[Docket No. NHTSA-2012-0039]

Federal Motor Vehicle Safety Standards; Platform Lifts for Motor Vehicles; Platform Lift Installations in Motor Vehicles

ACTION: Final rule.

FIGURE 2

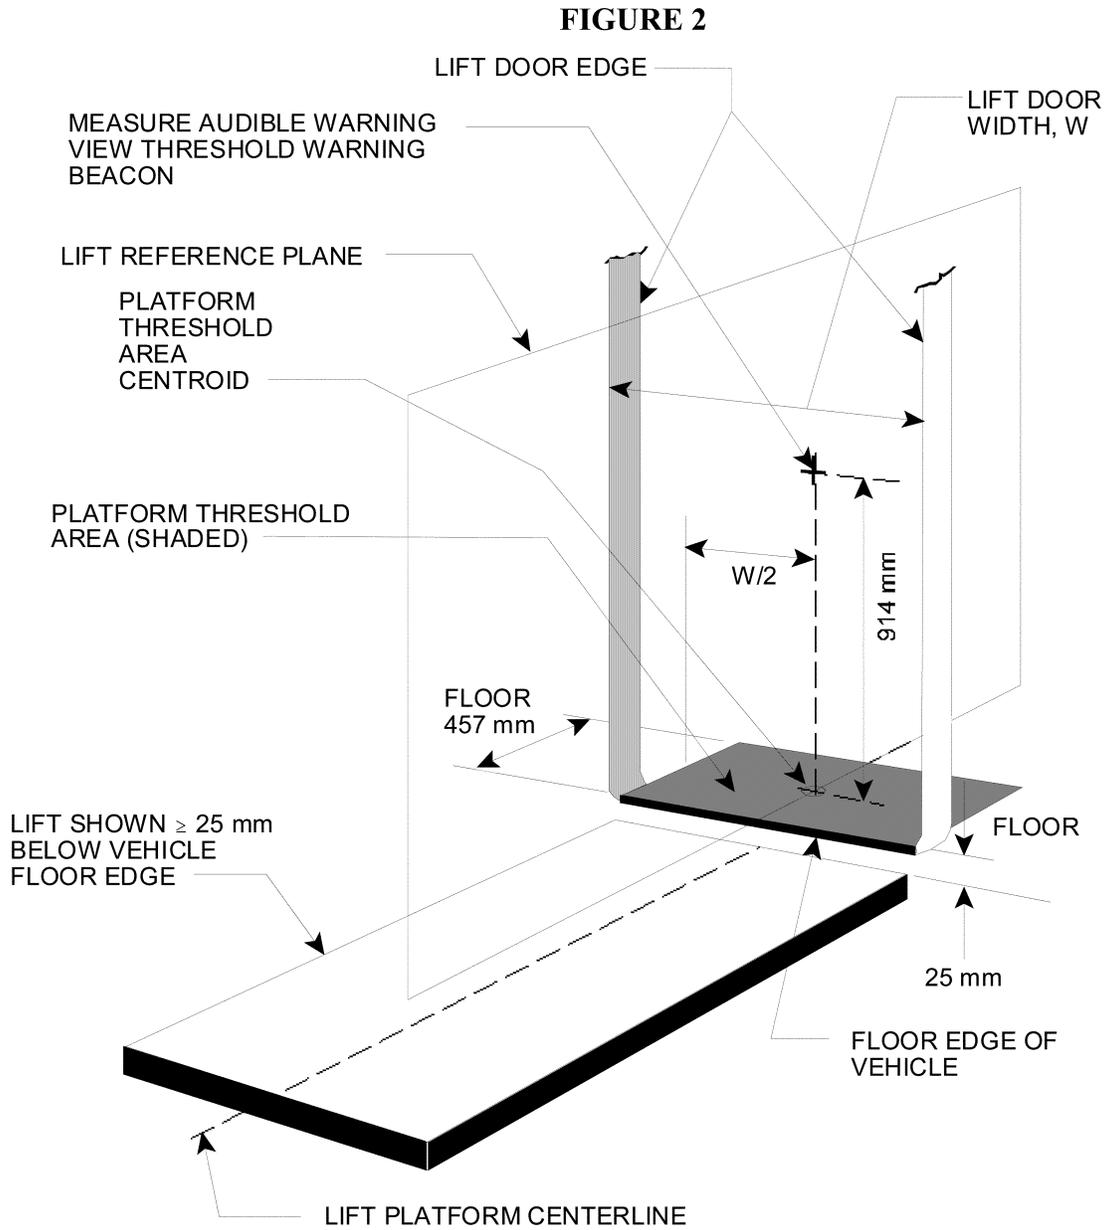
NHTSA also proposed a correction to Figure 2 of FMVSS No. 403. Currently, the height of the measurement point from which the intensity of the threshold audible warning is measured is identified as 919 mm. The proposed amendment would replace that distance with the correct measurement point of 914 mm (3 feet).

candela, a frequency from 1 to 2 Hz, and must be located within the interior of the vehicle such that it is visible from a point 914 mm (3 ft) above the center of the threshold area (see Figure 2) wherever the lift is installed and with any configuration of the vehicle interior.

S6.1.6 The intensity of the audible warning and visibility of the visual warning required by S6.1.2 and S6.1.3 is measured/observed at a location 914 mm (3 ft) above the center of the platform threshold area. (See Figure 2).
